RE: 400 Surmont Drive

I reviewed the drawings, and evaluated the site context. My comments and recommendations are as follows:

Proposed Cross Section

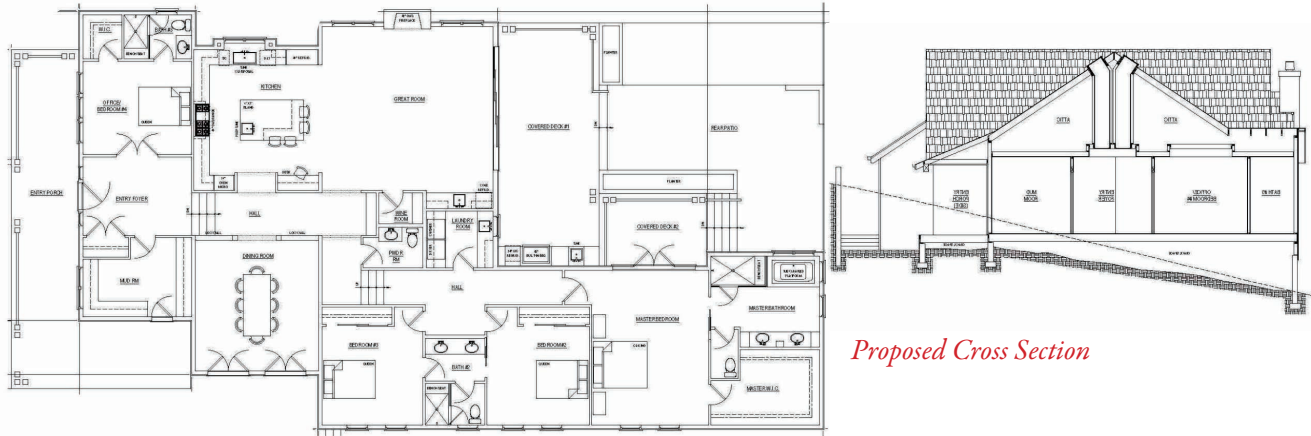
Window details are not provided, but viewing the building sections, it does not appear that the windows are adequately recessed for this architectural style without window trim. This would not be consistent with Residential Design Guideline 3.7.4.

Recommendations: Provide an adequate recess for all windows and assure that the size of the window head trim and sills are properly scaled for the size of the home.

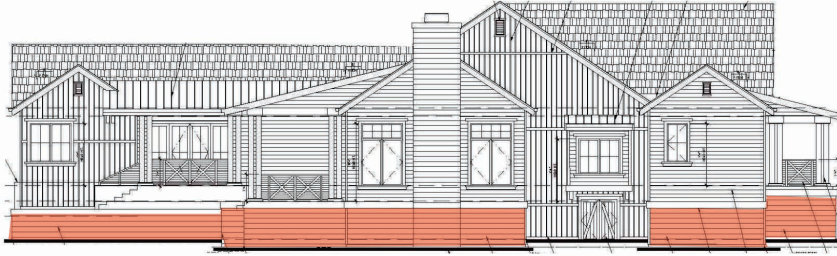
Two examples of recessed windows are shown in the photos below.

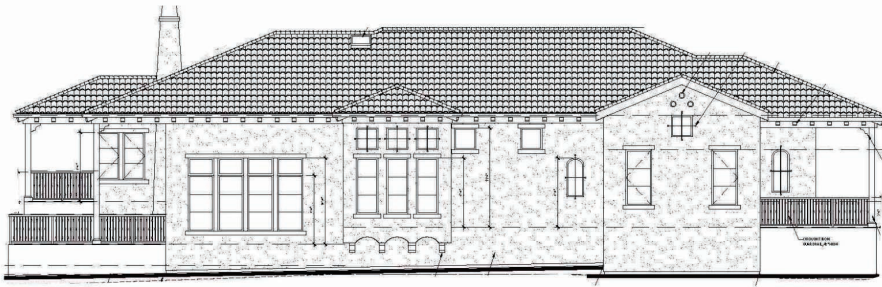
This will be a judgement call for the architect and applicant, but using board form concrete at the exposed base for the walls may not be best solution for this architectural style. On the downhill elevation where a substantial amount of the wall base is exposed, the result may be visually appear to be a refined wall material sitting on a podium of concrete - see diagram below.

I noted that on the Parcel 1 home downhill elevation, the stucco wall surface would extend down the full height of the wall - see comparable downhill elevation below.

Recommendations: Reevaluate the Parcel 2 building base materials, details and potential buffer landscaping.
